Appendix A-2
Draft EA Public Comment Documents

Summary Table of Responses to Draft EA Comments

Summary Response to U.S. Fish and Wildlife Comments on the Draft Environmental Assessment

Rain Event on S-Band Vertical Radar. Note the random directionality of most plots.
TrackPlots summarized at 15-minute intervals can easily be filtered out.

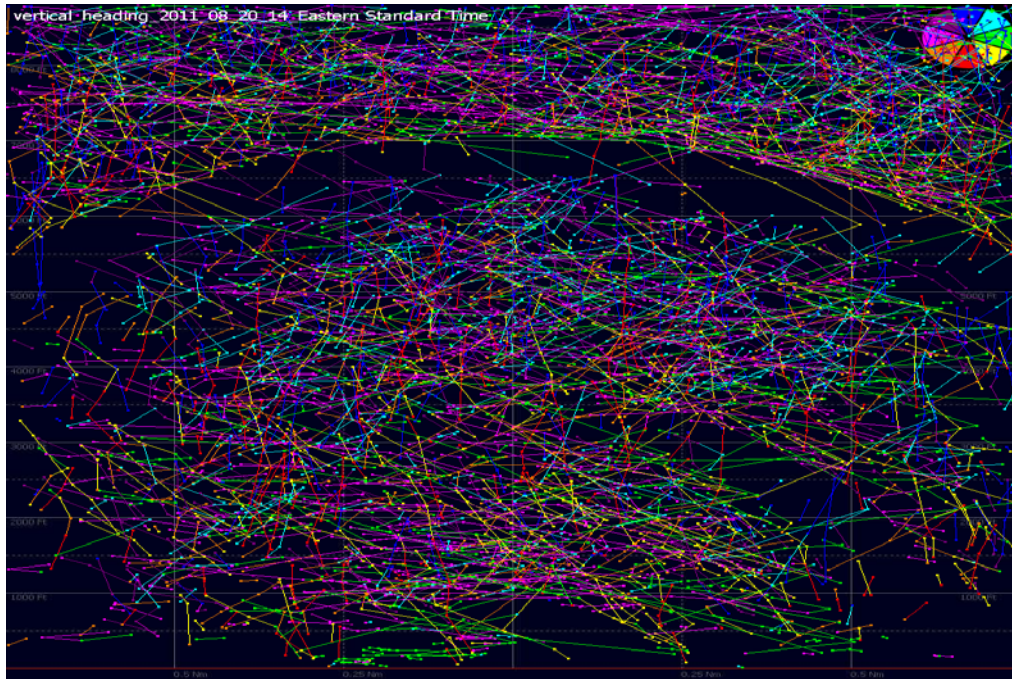
- Adequate pictorial examples of interference (waves, insects, rain) as well as high migration nights and observed phenomenon (e.g., reverse migration, directional patterns parallel to or going into shore) should be included in this report. Some examples are illustrated below:
